Access Compliance Report

Public Rights-of-Way

Intersection ID: 49102	Main Street: PROSPERITY_CROSSING_DR	Cross Street: BENFIELD_RD	Location: N
ADA ID: 865938CF8F92	Ramp Type: Directional1	Initial Pass/Fail: Fail	Overall Compliance: No
Severity Score: 13.75			
Codes/Mitigation Info/Possible Solution		Field Measurements/Component Compliance

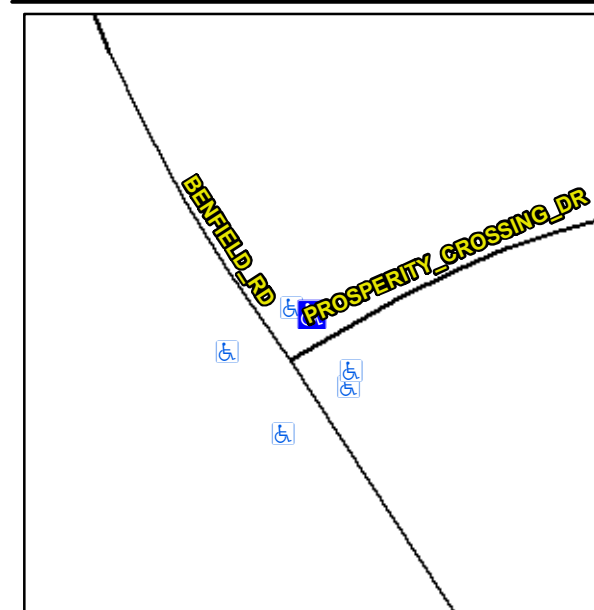
Remove & Replace Entire Ramp.

R304.2.2, R304.5.3
